Re: Immediate Response Action Plan Modification No. 4
50 Tufts Street
Somerville, MA
RTN 3-23246

On behalf of UniFirst Corporation of Wilmington, Massachusetts, we prepared this Immediate Response Action (IRA) Plan Modification No. 4 for a release of chlorinated volatile organic compounds (VOCs) at 50 Tufts Street in Somerville, Massachusetts (the Property). The IRA Plan was originally submitted to DEP on January 9, 2006 and subsequently modified on June 27, September 21, and November 13, 2006.

To: Ileen Gladstone, P.E., LSP
From: Jim Ash, P.E., LSP
Date: 1/17/2007
Re: Michael E. Capuano Early Childhood Center – Interim Sub-Slab Depressurization System Design
 GEI Project Number 04516-2

To: Ileen Gladstone, P.E., LSP
From: Jim Ash, P.E., LSP
CC:
Date: 1/22/2007
Re: Capuano Early Childhood Center – Response to DEP Request for Additional Information
 Interim Sub-Slab Depressurization System Design
 GEI Project Number – 045162

MONITORING POINT
LOCATIONS

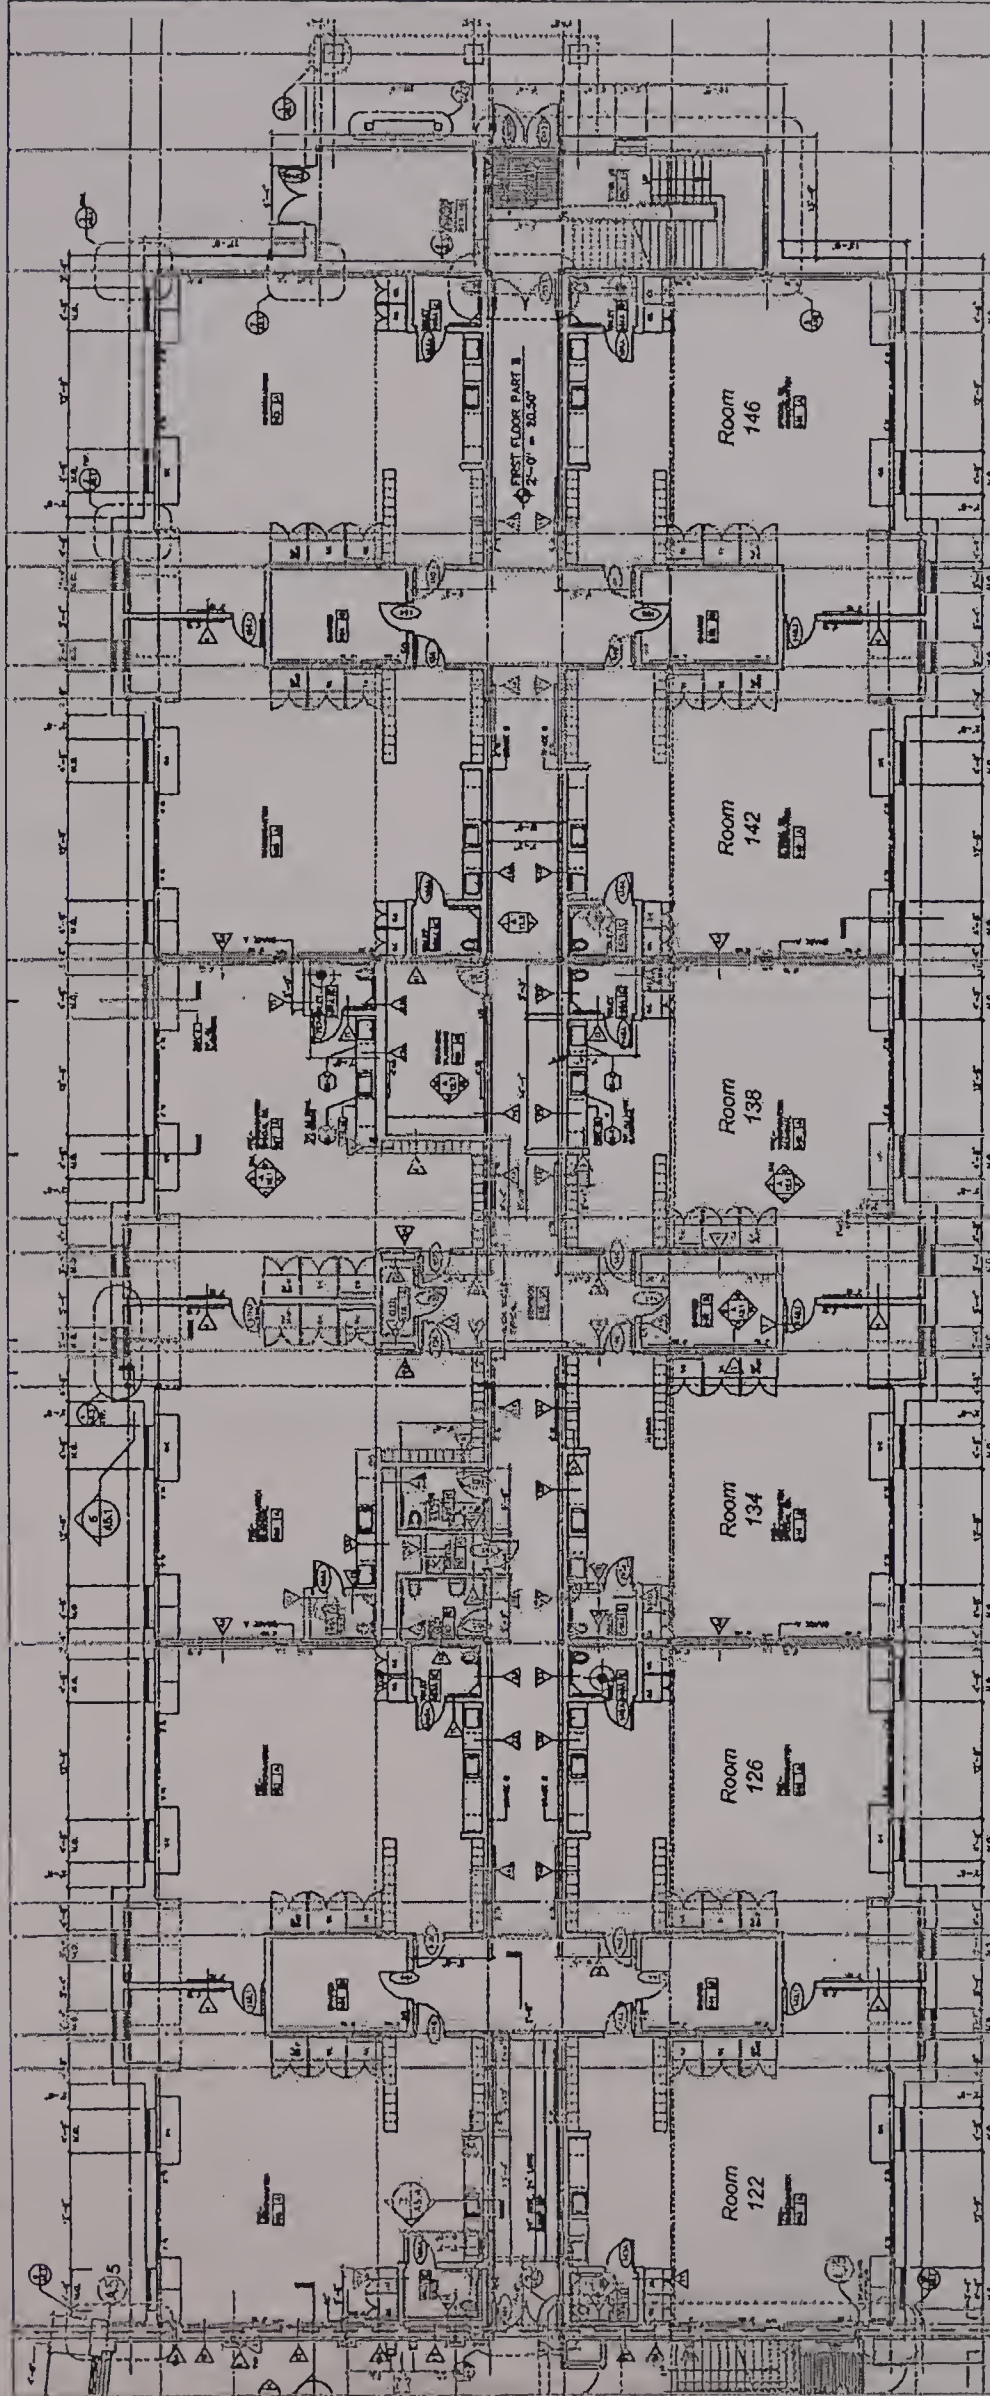
1. Prior and after start-up, the plan states Summa canisters will be used for 3 locations. Which 3? How will this be determined? Will the same 3 locations be used both before and after start-up?
2. One week after startup, you are planning to measure VOC concentrations on the roof 20 feet downwind. At the same time, I would also like VOC concentrations from the exhaust stack at the roofline using a ppbRAE.
3. After 3 months of operation, additional monitoring will be required. I'd like some kind of gauge so that a weekly mechanical check can quickly and easily be done. Will there be permanent pressure gauges, or permanent gauges for measuring the vacuum? Along with this I would like quarterly Summa canisters (48-hour turnaround not needed unless a problem is suspected).

2. What are the criteria for establishing the appropriate area of influence of the system?

Six sub-slab monitoring points will be installed inside the school at the same time that the interim system will be installed. Prior to start-up of the system we will measure:

- Subslab VOC concentrations at each of 6 monitoring points using a ppbRAE and collect subslab vapor samples using Summa canisters for laboratory analysis at 3 of the locations.
- Subslab pressure at each of 6 monitoring points using a manometer with a detection limit 0.01-inch water;
- Subslab VOC concentrations at each sub-slab piping penetration using a ppbRAE.

The primary criteria for the evaluating the effectiveness of the system is the effect on VOC concentrations in indoor air. Our goal is to reduce these concentrations to the extent feasible. The extent of influence of the system beneath the slab will be measured using a manometer with a detection limit 0.01-inch water. A reading of -0.01 inch of water or greater will be considered evidence of vacuum influence and an indication that subslab vapors are captured by the system.
